Technical Information Bulletin

44-028

T880 PX-9 Return Fuel Fitting

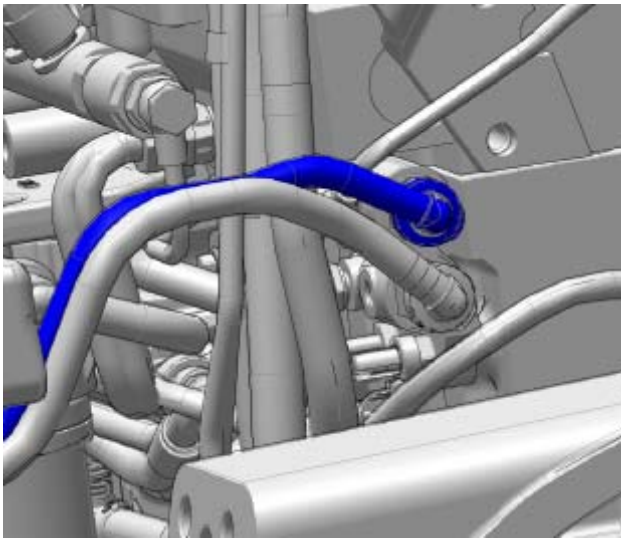
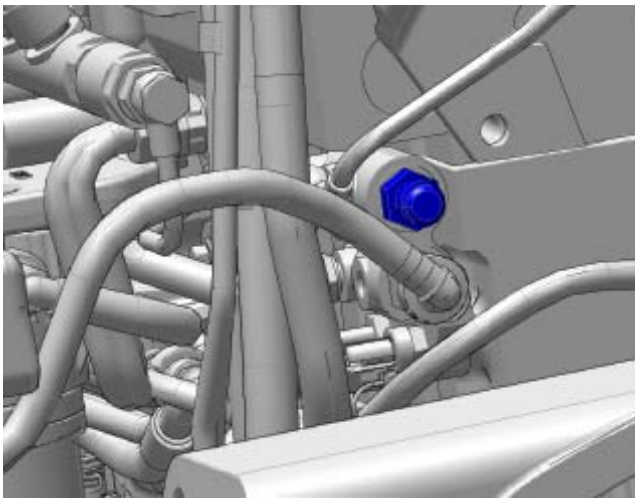
Potential for O-ring fuel leak.

Your vehicle (listed within this letter) is eligible for a campaign to replace the return fuel fitting. The fitting may have been manufactured with an enlarged sealing area which could lead to a potential fuel leak.

1. Remove the return line from the fitting.

2. Remove the return fitting from the engine.

3. Install the new return fitting and torque it to 95 N·m (70 lb-ft).
4. Connect the return line to the fitting.
